## RE: Town of Peshtigo Board Meeting Update

SUBJECT: Response to *GETS Progress Report #3 (Nov. 13, 2023 – May 12, 2024)*  
JCI/Tyco FTC PFAS, 2700 Industrial Parkway South, Marinette, WI  
BRRTS #02-38-580694

In this letter, the DNR provides a review of the groundwater extraction and treatment system (GETS) relative to the performance criteria JCI/Tyco set for this interim remedial action and requests that JCI/Tyco respond to questions the DNR has on JCI/Tyco's proposed updates to the GETS.

### Ditch B PFAS Mini-Piezometer Concentrations

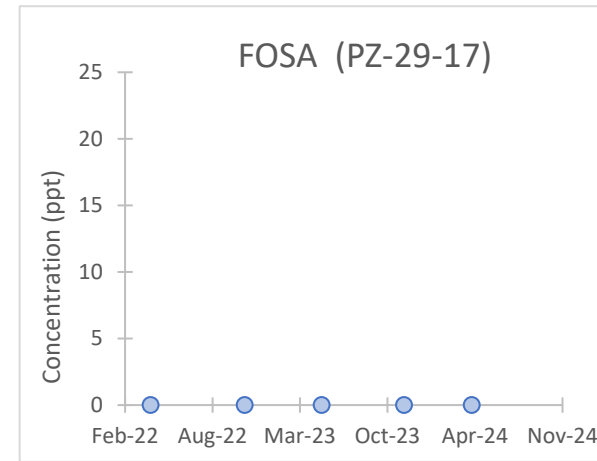
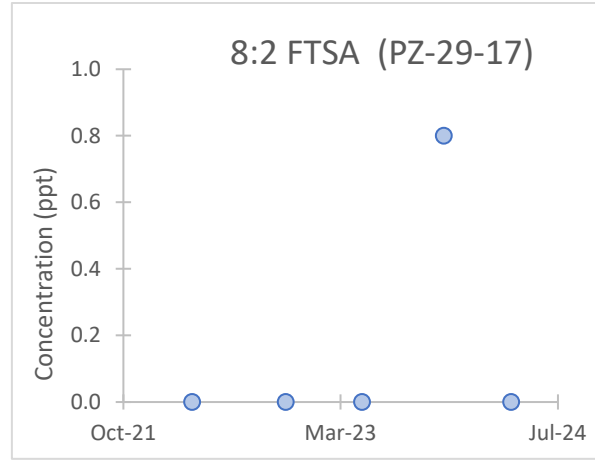
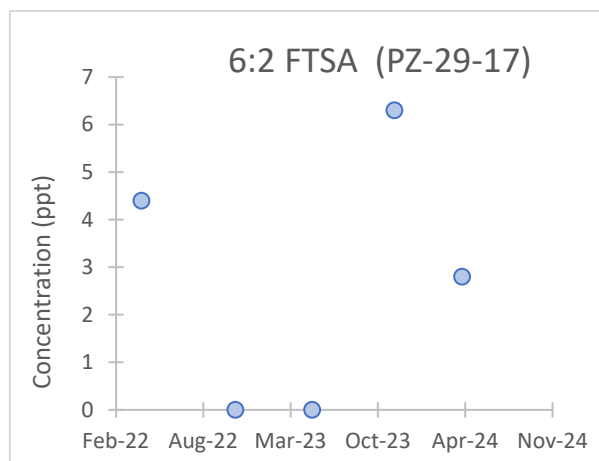
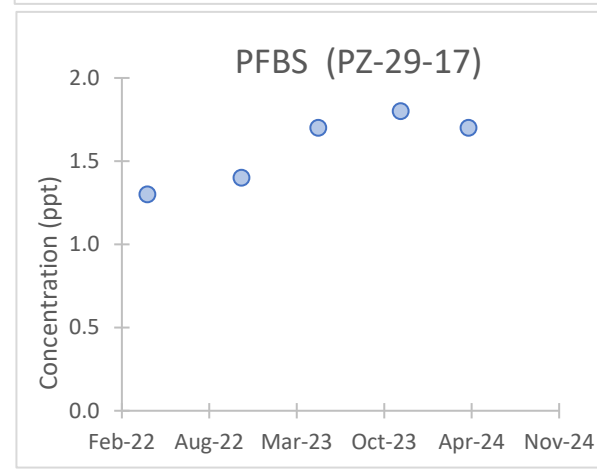
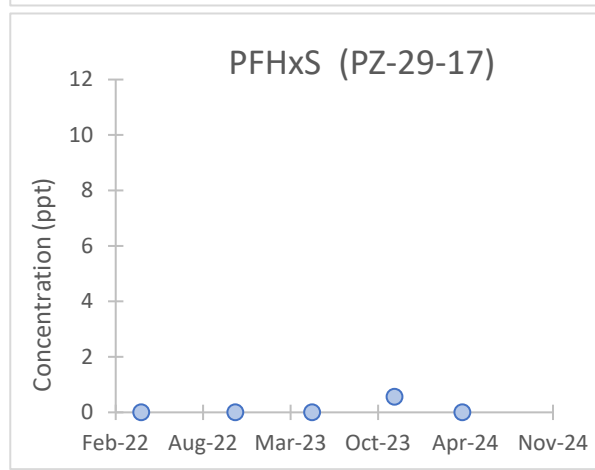
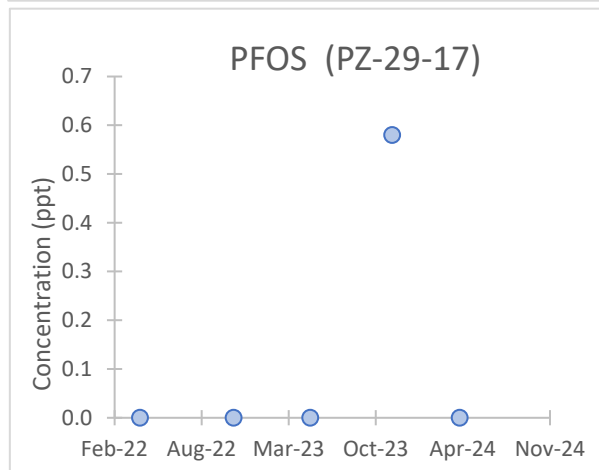
One likely contribution to these exceedances is the upwelling of contaminated groundwater that persists, albeit reduced, between monitoring points U10 through M07 as discussed above in item 1 and as shown on the first figure in Attachment B. JCI/Tyco's supplemental monitoring of surface water during this reporting period for points along the tributary to Ditch B near Pierce Avenue revealed that groundwater upwelling introduces PFAS contamination to this surface water tributary that enters Ditch B upstream of extraction well EX-3, near monitoring point M09.

As noted in Attachment A, JCI/Tyco should prepare trend plots to evaluate the cause of the elevated PFAS concentrations detected in Ditch B. These plots include, spatial plots of PFAS concentrations from the streambed mini-piezometers (see example in Attachment B) and temporal plots that overlay streamflow rate with PFAS concentrations at selected locations.

### Groundwater PFAS Concentrations

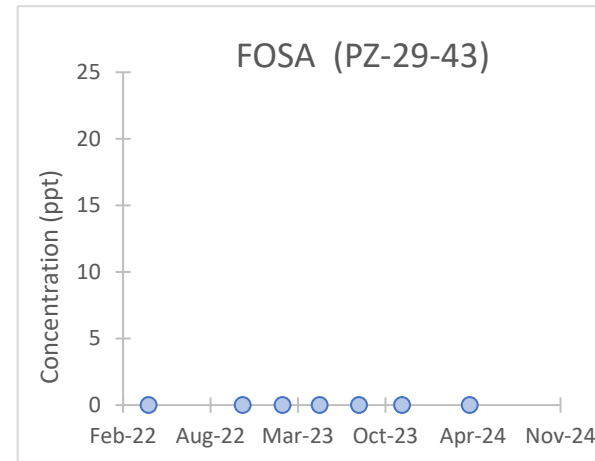
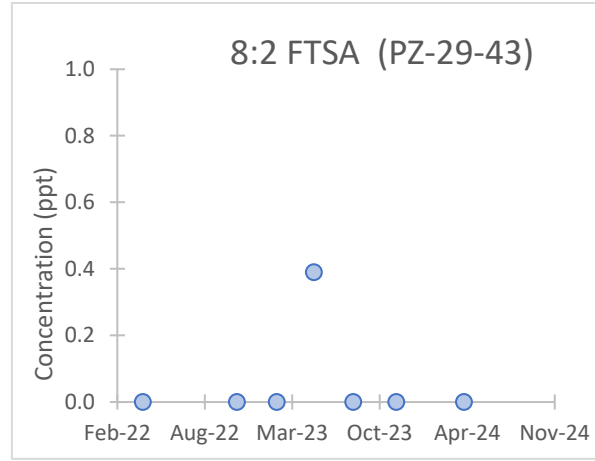
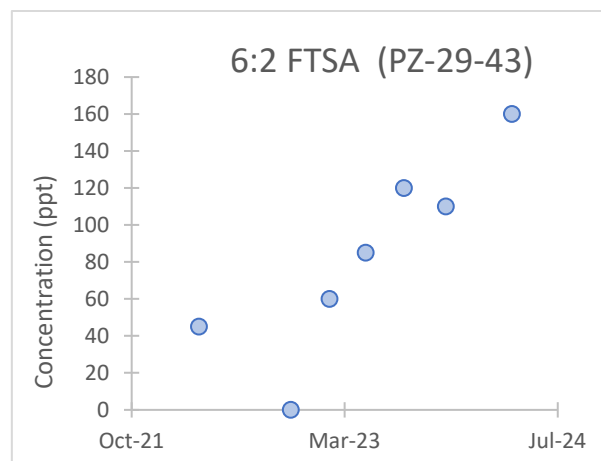
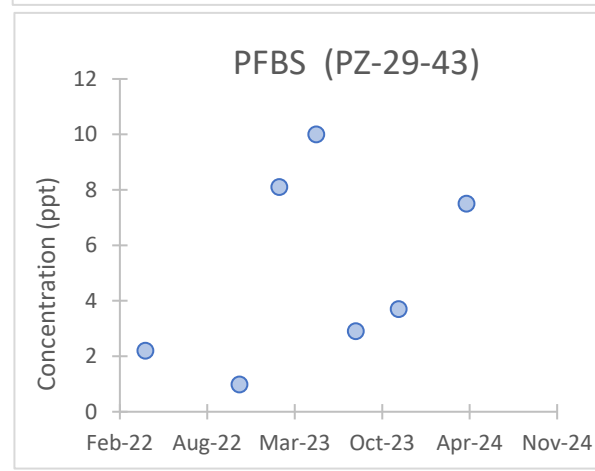
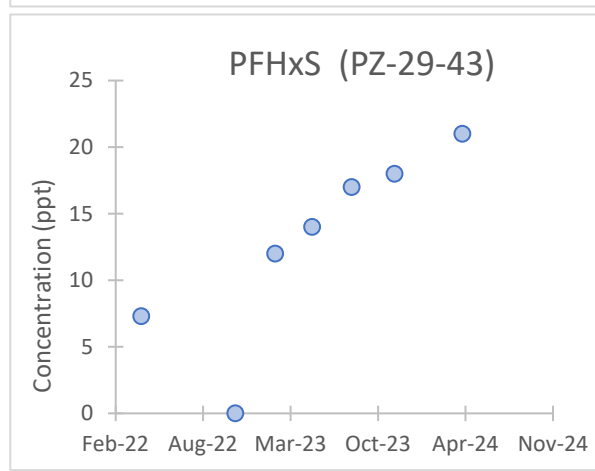
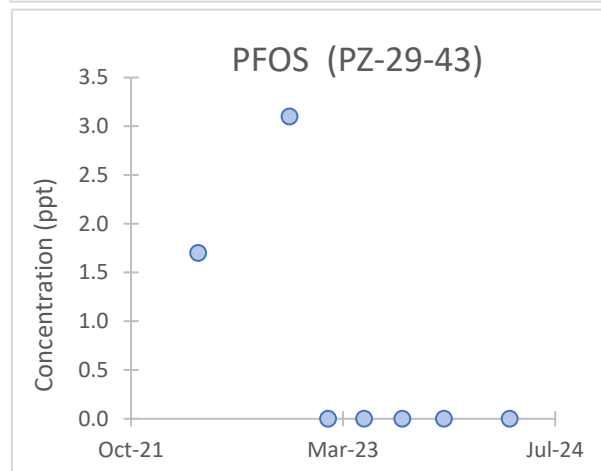
As noted in Attachment A, the DNR recommends that JCI/Tyco add trend plots for certain PFAS in selected wells within the area of influence of the GETS (see example in Attachment B).
